# **Review of Westinghouse AP1000 LLW Management Program**

**1008016**

Final Report, November 2003

**FIGURE 11.4-1 FROM AP1000 DESIGN CONTROL  
DOCUMENT**

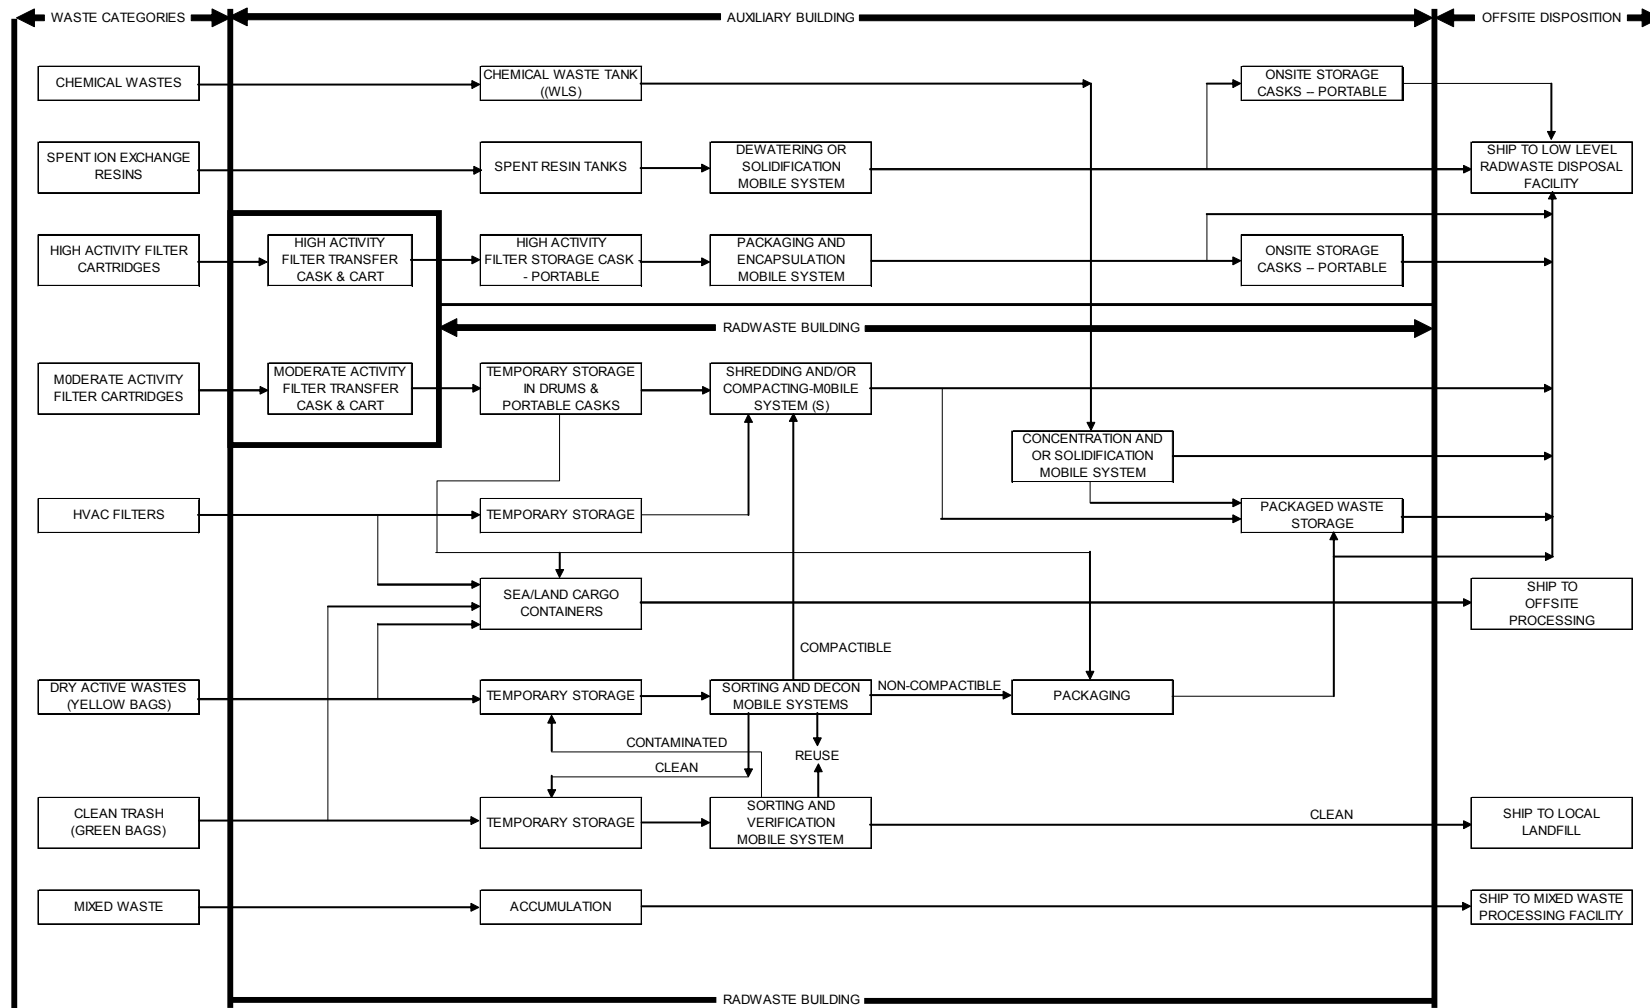
Figure 11.4-1 (page 11.4-35) of the DCD provides substantial flexibility for the dispositioning of DAW. However, additional flexibility could be added for wet solid wastes (resin, filters). Consideration should also be given to allow all waste to go directly to an off site processor or directly to a disposal site. Therefore, consideration should be given to the following options to Figure 11.4-1:

- a. A bypass with a deionized water flush capability should be considered to allow spent ion exchange resin to bypass the spent resin tanks and go directly to a HIC or liner in the spent resin container fill station at the west end of the rail car bay of the auxiliary building. The container and fill station are discussed in paragraph 11.4.2.1; the bypass is not discussed, and the bypass is not shown in Figure 11.4-1.

- d. HVAC filters, DAW in yellow bags, and clean trash in green bags are all shown with an option to be placed into sealand containers and shipped to an off site processor. An additional option should be added to allow for direct disposal from the sealand container.

- a. Paragraph 11.4.2.3.3 makes reference to the management and disposition of clean waste generated within the radiological control area (RCA). Figure 11.4-1 also indicates dispositioning options for clean waste. Because this waste is not “radwaste,” it is not addressed in Table 11.4-1 and is not otherwise quantified. This has a significant cost impact and should somehow be projected. Typically, a PWR generates a clean waste volume equal to the annual DAW volume. It is not clear how this could be captured in the DCD, but a discussion of typical generation volumes should be included.

- d. The most common approach to managing DAW in U.S. commercial nuclear plants is to accumulate waste in sealand containers, which is included in the waste flowpath as an option (Figure 11.4-1). Ideally, space would be provided for four side-by-side 20' long sealand containers for the accumulation of segregated waste: 2 for DAW, 1 for metal, and 1 for clean RCA trash. None of these sealand containers could fit into the waste accumulation room. Paragraph 11.4.2.4.2 states that the mobile systems facility has a designated laydown area for a sealand (cargo) container, which can be handled by the facility crane. Consideration should be given to additional containers.

The ALWR LLW committee believes that this appears to be a simple and appropriate administrative fix which should be included in the DCD. As it currently exists, it does not correctly reflect the existing written discussions in Section 11.4 for waste dispositioning. Relying on a future document to correct inconsistencies provides opportunities for confusion and error.
